# Access Compliance Report

### (Curb Ramps)

Intersection ID: 24360	Main Street: BIRNEN_DR	Cross Street: ESSEN_LN	Location: NW
ADA ID: AB594B1678C8	Ramp Type: PerpDiag	Initial Pass/Fail: Fail	Overall Compliance: No
		Severity Score: 22.5

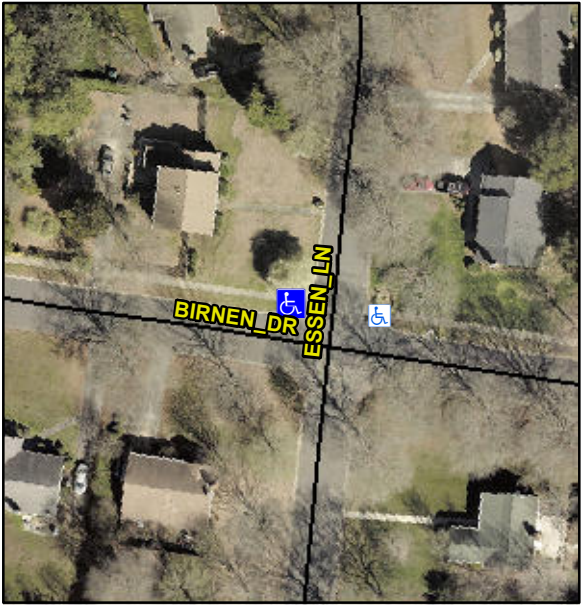
Codes/Mitigation Info/Possible Solution			Field Measurements/Component Compliance		
	Possible Solutions:		<b>Compliance</b>	<b>Description</b>	<b>Data</b>
	<b>Remove &amp; Replace Curb Ramp With Two New Directional Ramps or Equivalent.</b>		<b>No</b>	Ramp Length (in)	77.0
			<b>No</b>	Ramp Width (in)	45.0
			<b>N/A</b>	Flare Type LT	N/A
			<b>N/A</b>	Flare Slope LT (%)	N/A
			<b>N/A</b>	Flare Traversable LT?	N/A
			<b>N/A</b>	Landing Length (in)	N/A
			<b>N/A</b>	Landing Width (in)	N/A
			<b>N/A</b>	Landing Slope (%)	N/A
			<b>N/A</b>	Landing X Slope (%)	N/A
<p>Surveyor Notes:</p> <p><b>N/A</b></p> <p>PROW/ADA:</p> <p><b>Not Found, R304.5.1, R304.2.2, R304.5.3</b></p>			<b>N/A</b>	Flare Type RT	N/A
			<b>N/A</b>	Flare Slope RT (%)	N/A
			<b>N/A</b>	Flare Traversable RT?	N/A
			<b>N/A</b>	DWS Provided?	N/A
			<b>N/A</b>	DWS Contrast?	N/A
			<b>N/A</b>	DWS Length (in)	N/A
			<b>N/A</b>	DWS Full Width?	N/A
			<b>N/A</b>	DWS Offset (in)	N/A

<b>N/A</b>	Gutter Ponding?	N/A
			<b>N/A</b>	Gutter Lip Ht (in)	N/A
<p>Total Cost:</p> <p><b>\$ 3200.00</b></p>			<b>No</b>	Painted X Walk1?	No
				X Walk 1 Direction	To SW
			<b>N/A</b>	X Walk 1 Width (in)	N/A
			<b>3.5</b>	X Walk 1 Slope (%)	
			<b>2.5</b>	X Walk 1 X Slope (%)	
			<b>N/A</b>	Ramp inside XWalk1?	N/A
			<b>0.9</b>	Road Slope (%)	N/A
			<b>4.8</b>	Road X Slope (%)	N/A
			<b>N/A</b>	Any Obstructions?	N/A
				Obstruction Type	
			<b>N/A</b>	Storm Grate/Utility Hazard?	N/A
				Storm Grate/Utility Type	
			<b>N/A</b>		N/A
			<b>Yes</b>	Surface Condition? (G/P)	Good
